To: Department of Natural Resources Date: 5/17/93
Richards Street Annex Subject: Well Abandonment
4041 Richards St At Timmerman Field
PO BOX 12436
Milwaukee, WI 53212
 Attn: John Feeney Job. No. 255115363

RE: WDNR Letter of January 27, 1993, Concerning Timmerman Field (C-26, 27)
9305 West Appleton Avenue, Milwaukee

RE: Petroleum contamination at Timmerman Airport, 9305
West Appleton Avenue, Milwaukee (USTs C-26, C-27)

**REMEDIAL INVESTIGATION
FOR
TIMMERMAN FIELD SITE
(USTS C-26 AND C-27)**

MILWAUKEE COUNTY UST MANAGEMENT TIMMERMAN FIELD SITE	
Brookfield Lakes Corporate Center XII 175 N. Corporate Drive, Suite 100 Brookfield, Wisconsin 53045			EXCAVATION SITE LOCATION	
Dsgn. by:	Chk. by:	Apprv. by:		
PROJECT: 255115363	DATE: 08/11/92	DRAWING NO.: 1538-3	FIGURE: 2-2

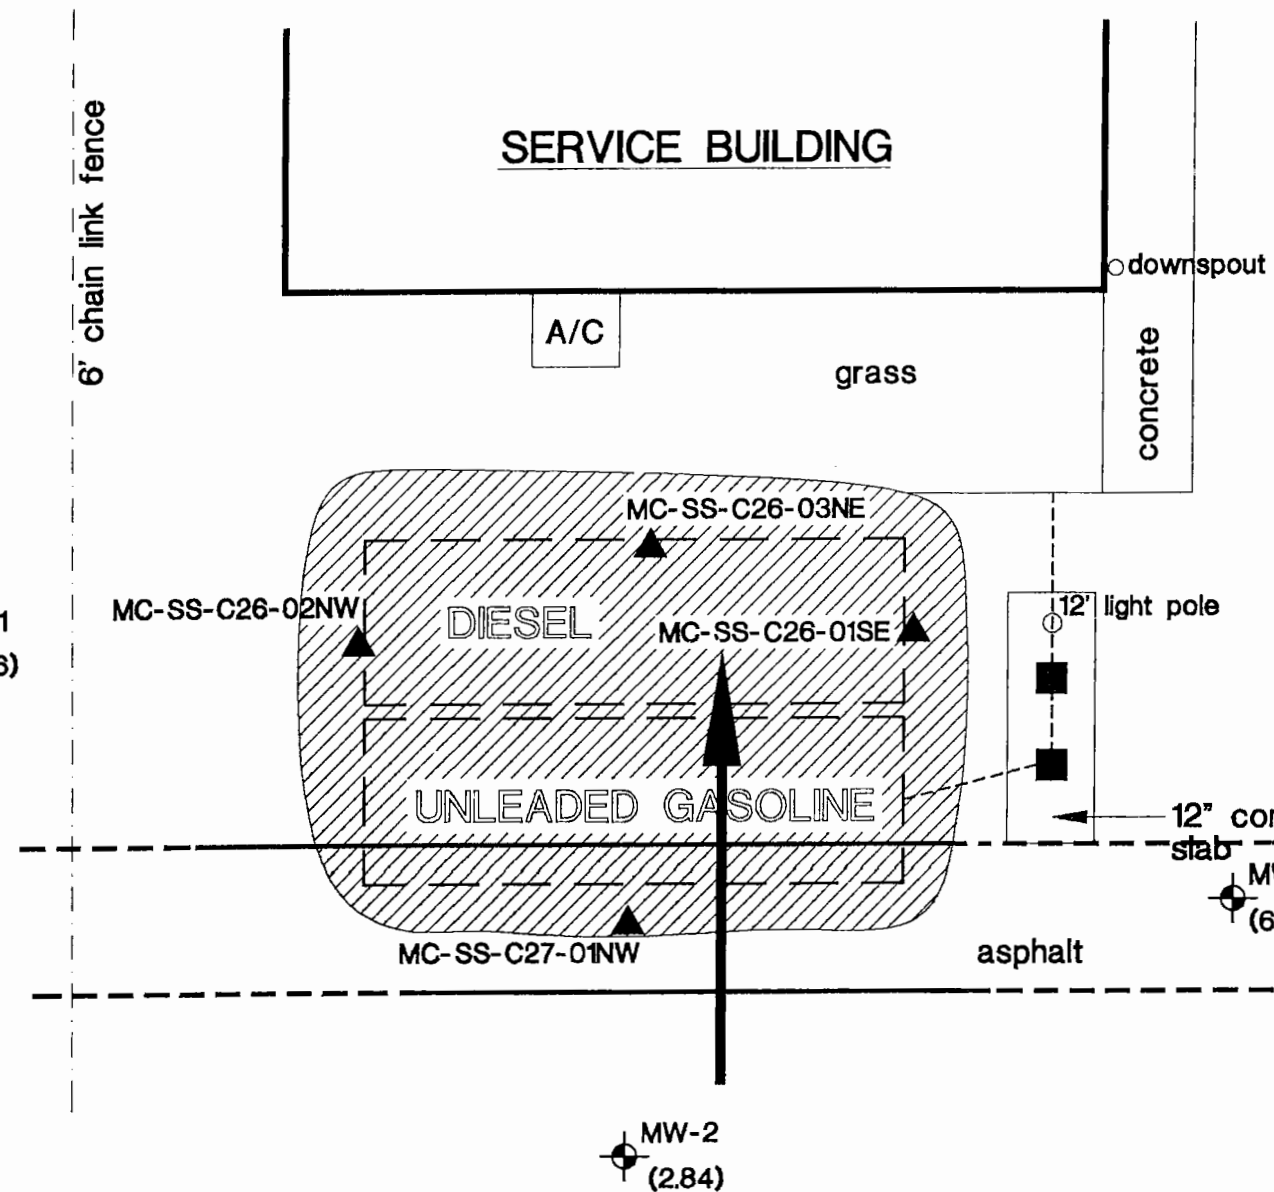
I have looked at your case based on the UST closure assessment and the remedial investigation report in our file. I request that a well be completed and sampled directly downgradient from the former tank bed location for the following reasons:

1. A water sample taken from the tank excavation was contaminated above enforcement standards.
2. The wells in place may not be in a position to intersect the contaminant plume.

I am forwarding this report to you as a release to be taken up by the closure committee. I think that at the very least another monitoring well should be installed downgradient of the tank site. Call me if you have any questions at 608 264-6041.

- ◆ The additional monitor well cannot be installed to the immediate east of the UST excavation due to the presence of electrical, sewer, and water utilities between the USTs and the building located approximately 10 feet away.
- ◆ The only available location east of the UST excavation is east of the building, approximately 60 feet to 70 feet from the UST excavation. Based on the dense silty clay and other site hydrogeologic information, this is too large a distance to provide meaningful information on the extent of impacts.
- ◆ Water levels of the three existing monitor wells were checked on February 4, 1993 following receipt of Mr. Feeney's letter. The depth to water (DTW) below the top of casing for the June 9, 1992 measurements and the February 4, 1993 measurements are tabulated below:

- ◆ The June 9, 1992 water levels were used to infer that the ground-water flow direction was to the east in the August 14, 1992 report. The February 4, 1993 water levels dispute this inference. The variability in the ground-water levels in the wells is reflective of variability in the amount of surface infiltration surrounding each well. Due to the wide variation in the water levels, no reliable determination of the ground-water flow direction can be made.
